XS1100H/LH/SH
DRIVE AXLE BEARING COLLAR

AFFECTED MODELS

All XS1100H, XS1100LH, and XS1100SH

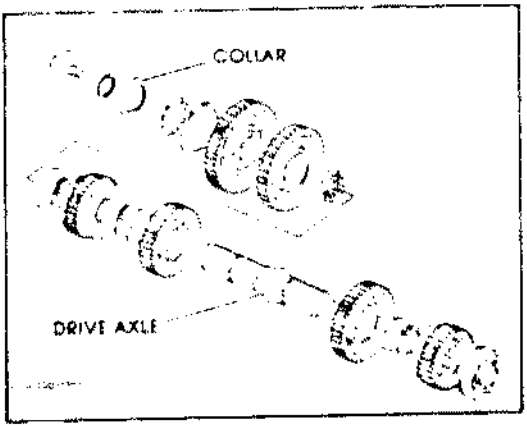
A new-style bearing supports the right-hand side of the transmission drive axle on the affected models. This new-style bearing is a single-row ball bearing rather than a double row bearing as used in previous XS11s. Since the new-style bearing is 3mm narrower than the bearing previously used, a collar has been installed between the bearing and the crankcase to maintain the proper clearances in the transmission. This collar is directional; it must be installed with the beveled edge toward the crankcase and away from the bearing.

If the collar is positioned improperly during assembly, the crankcase will be damaged when the drive axle bearing is installed. Be sure the bearing collar is installed correctly before pressing the drive-axle bearing into the crankcase.
